Planning Commission Agenda

Tuesday, December 17, 2024 at 7:00 PM
27400 Southfield Road, Lathrup Village, Michigan 48076

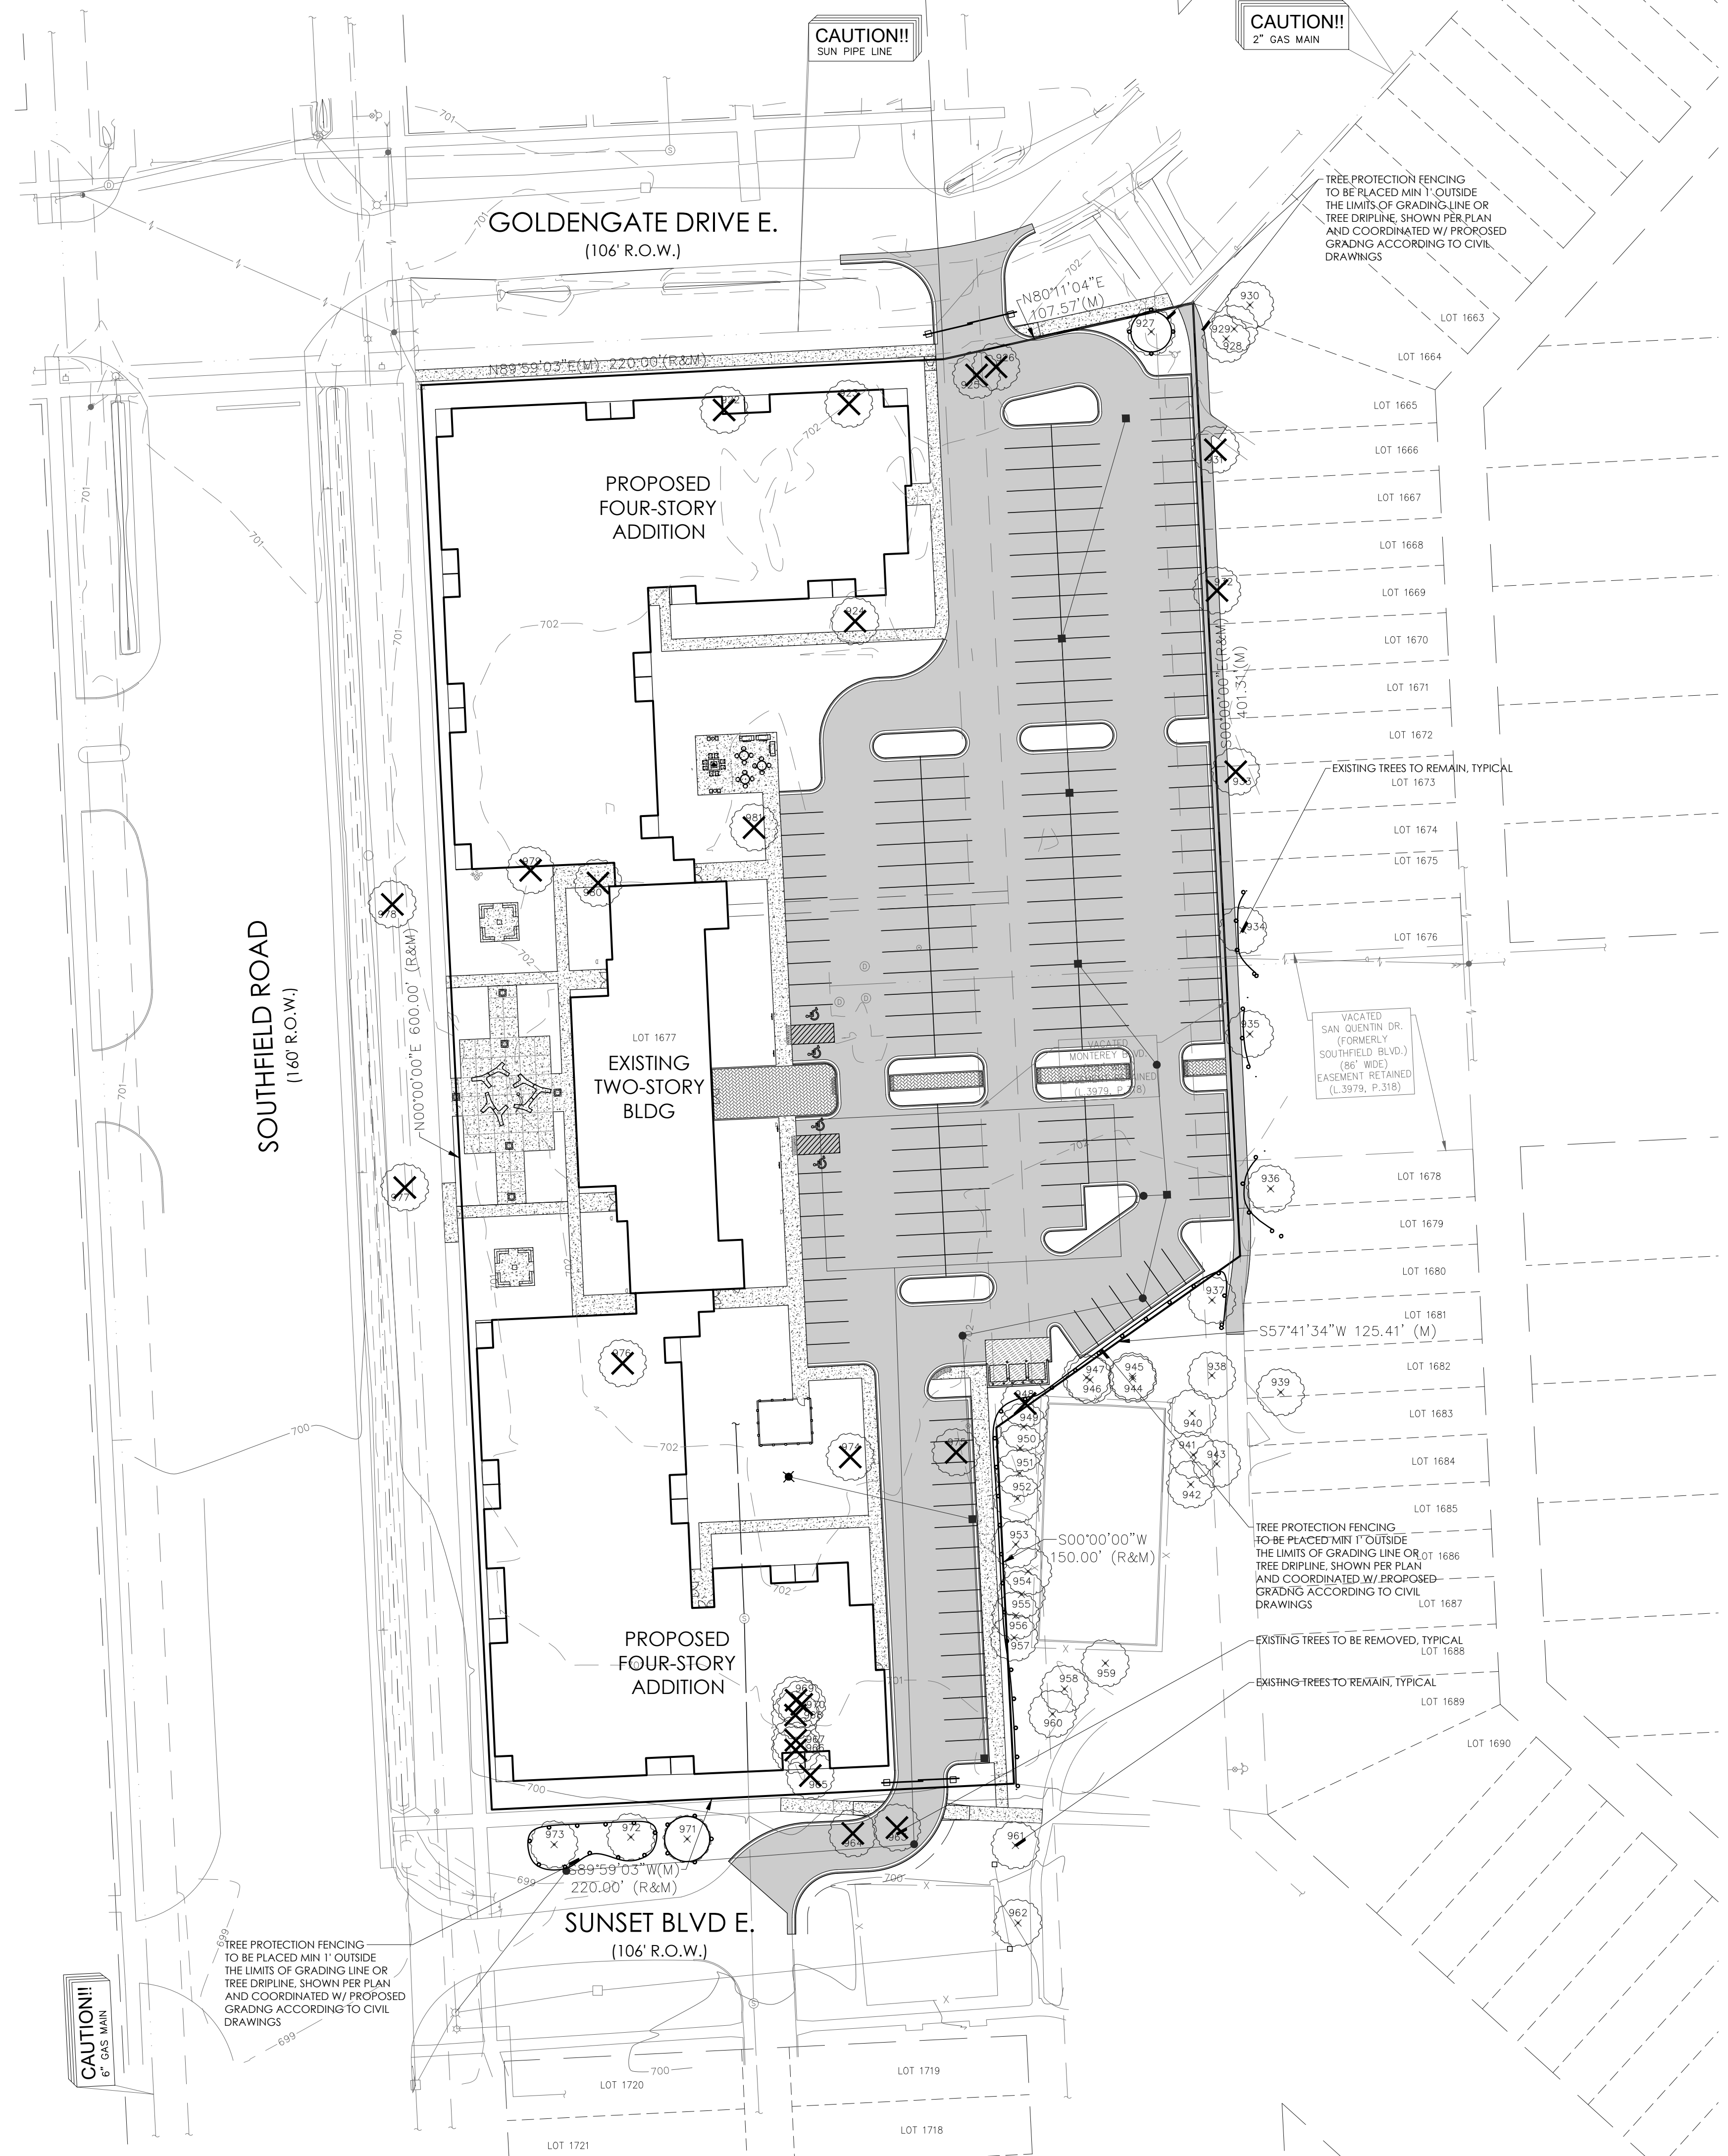
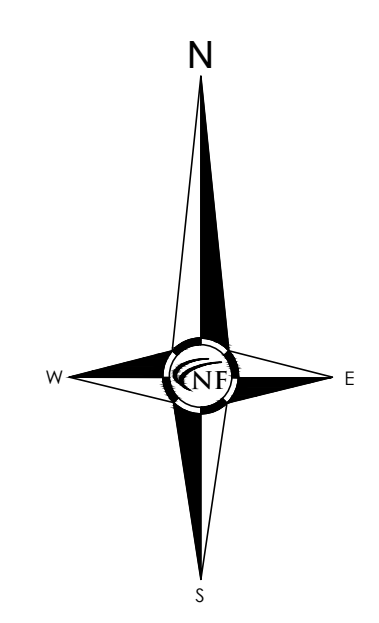
REVISIONS
10/17/2024 ISSUED FOR SITE PLAN REVIEW

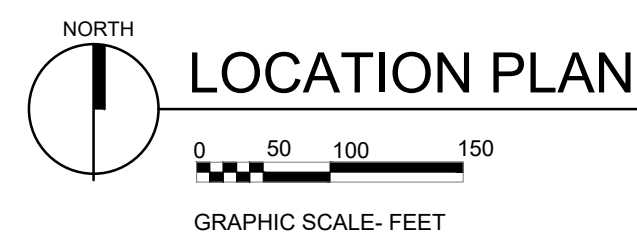
Issued for
SITE PLAN REVIEW 10.18.24

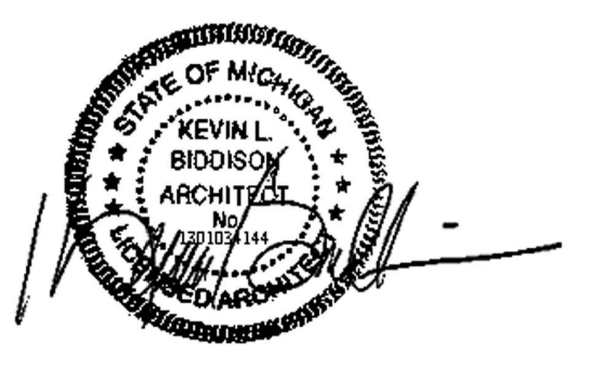
SITE PLAN REVIEW 10.18.24

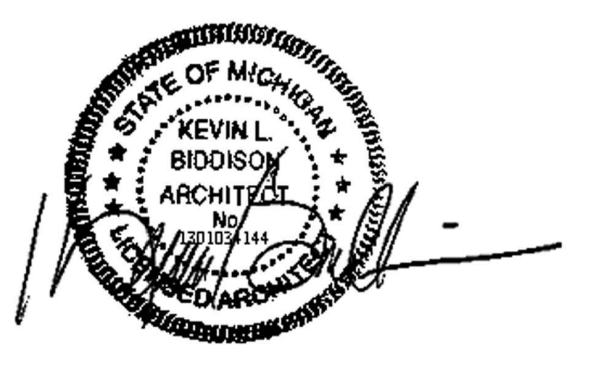
SITE PLAN REVIEW 10.18.24

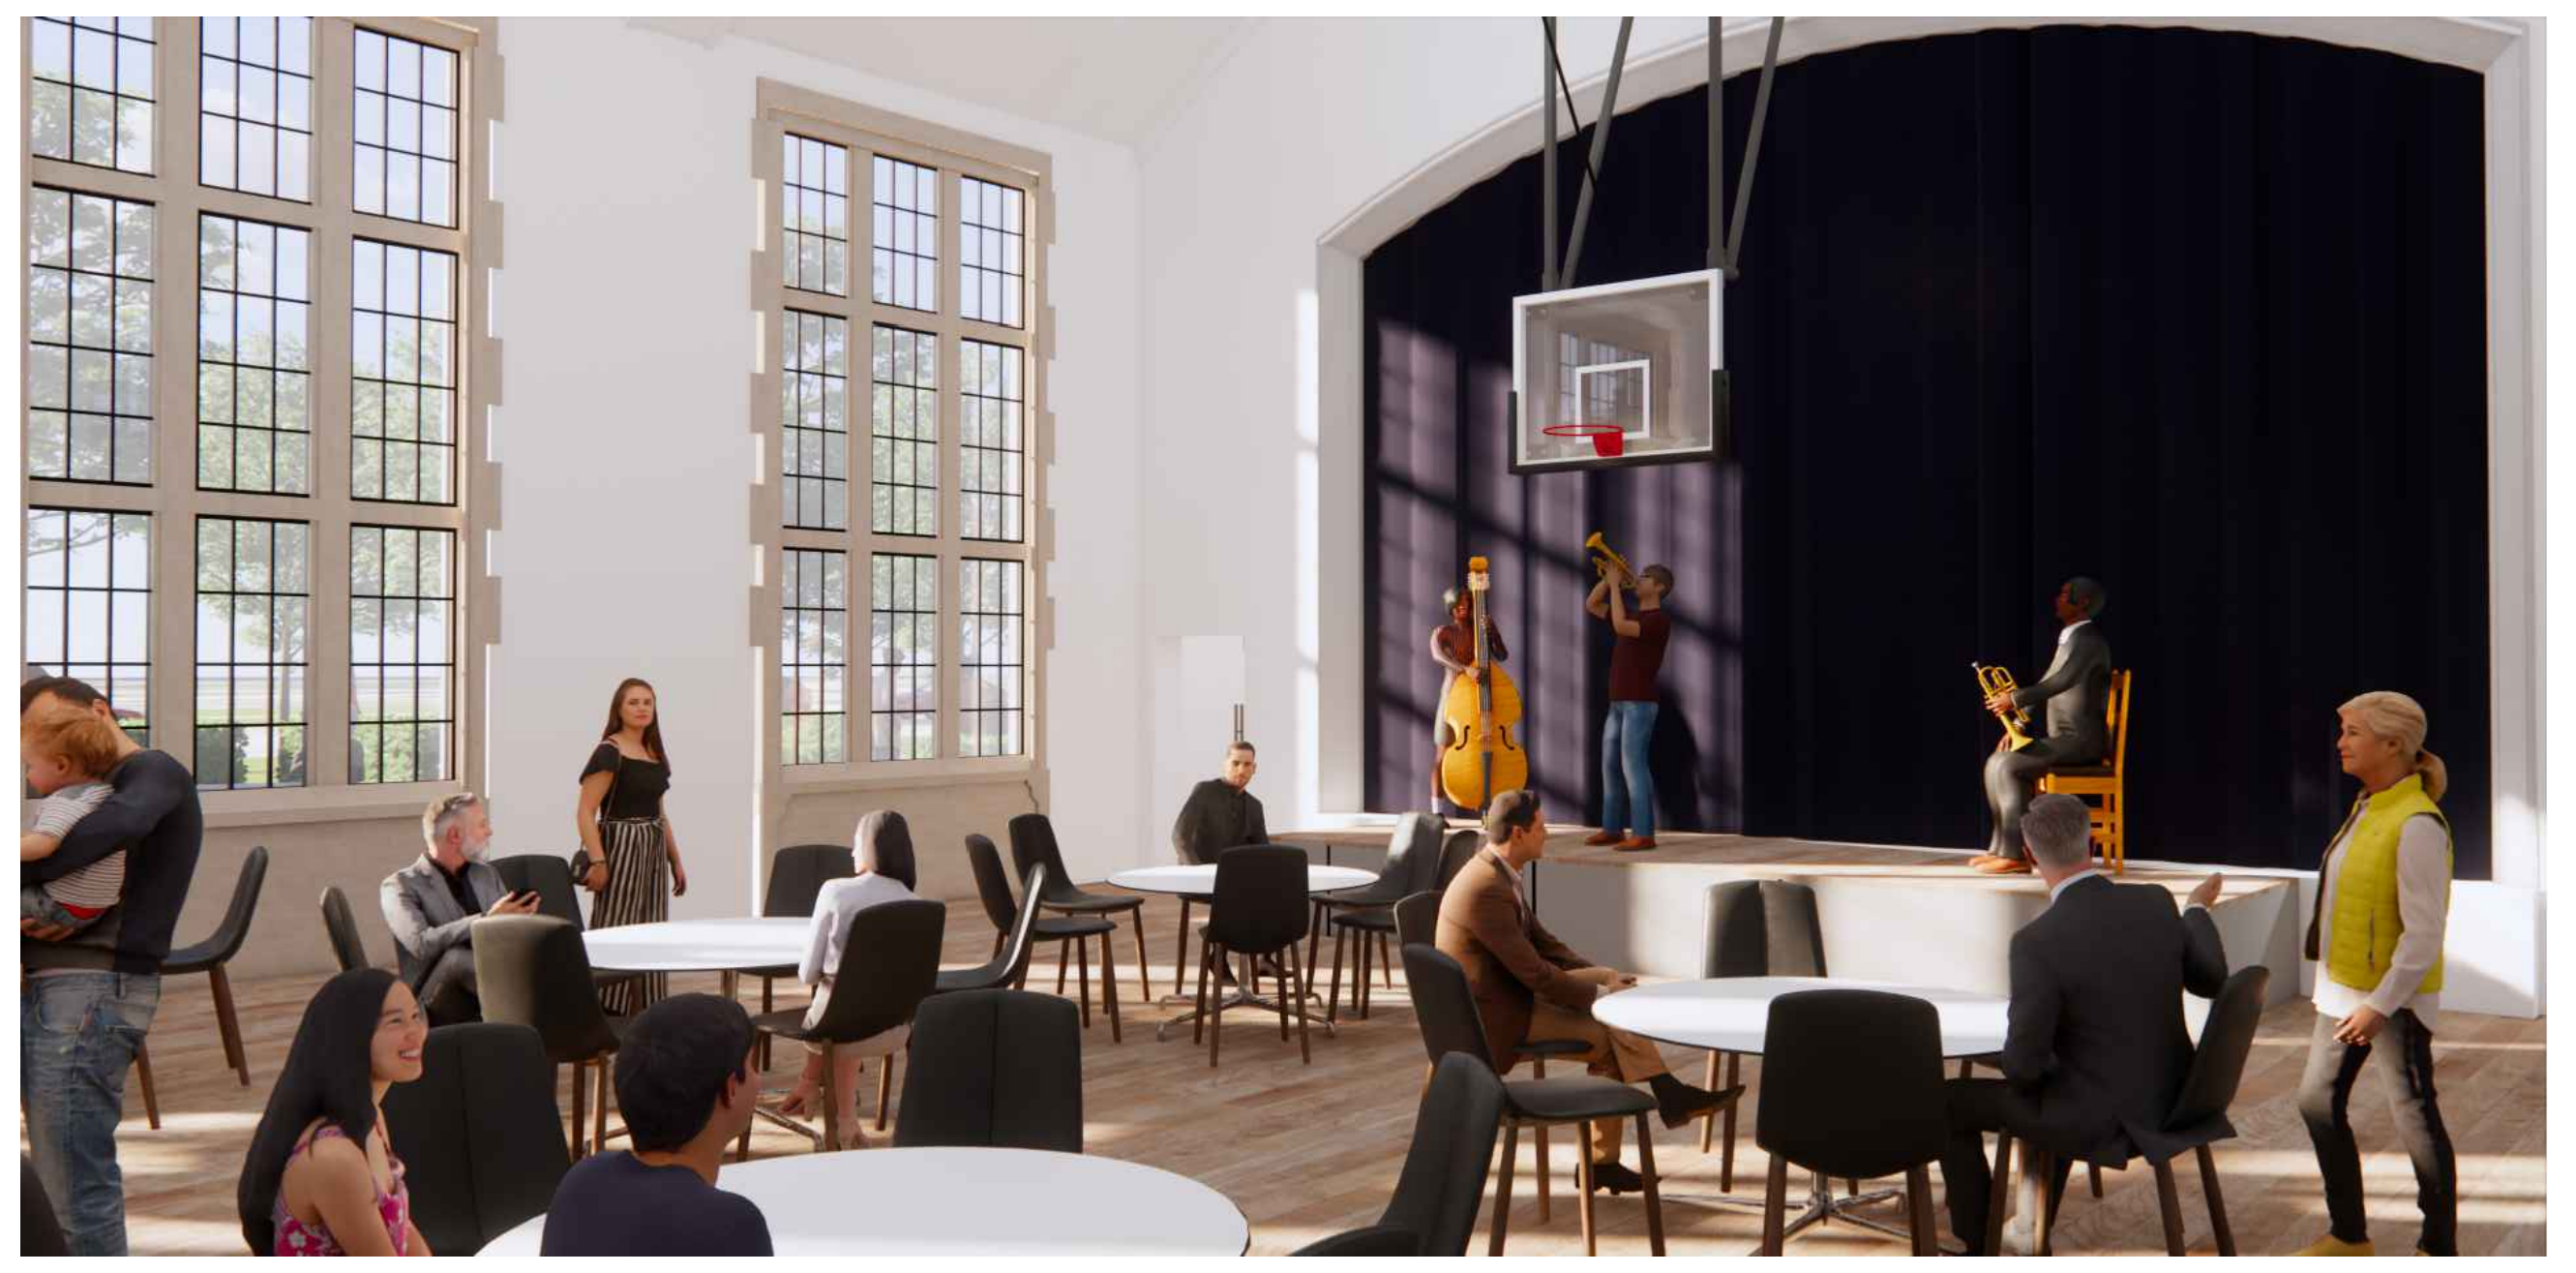
SITE PLAN REVIEW 10.18.24

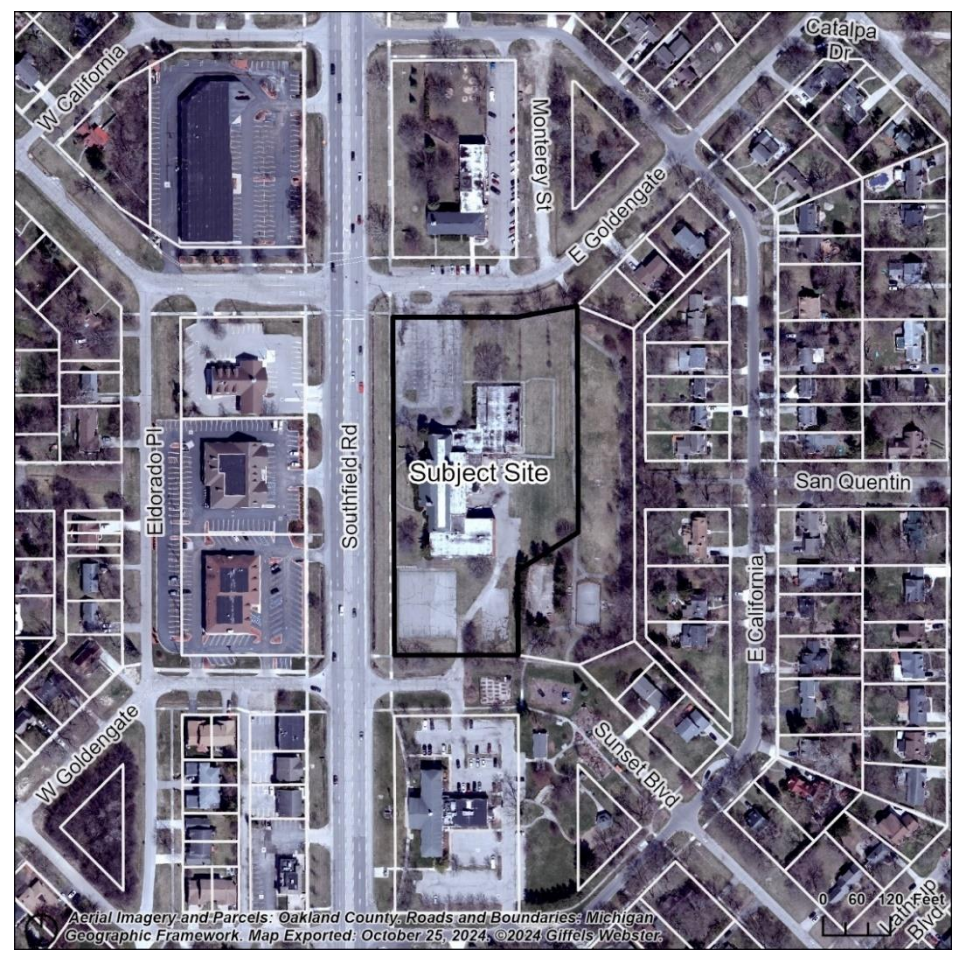
Site Plan Review

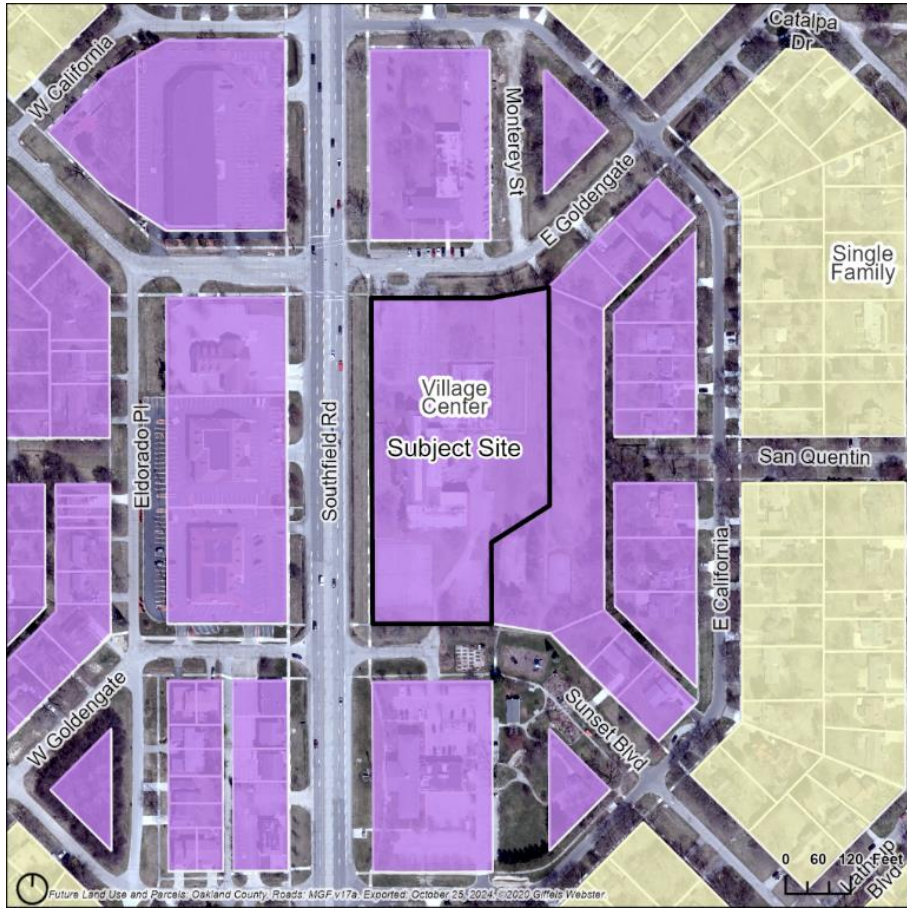
We are available to answer questions pertaining to this site plan review.

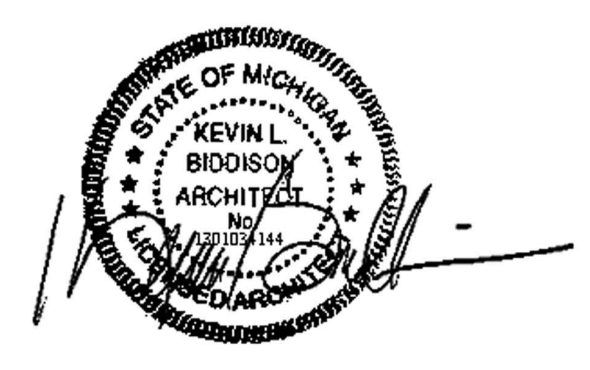
SITE PLAN REVIEW 10.18.24
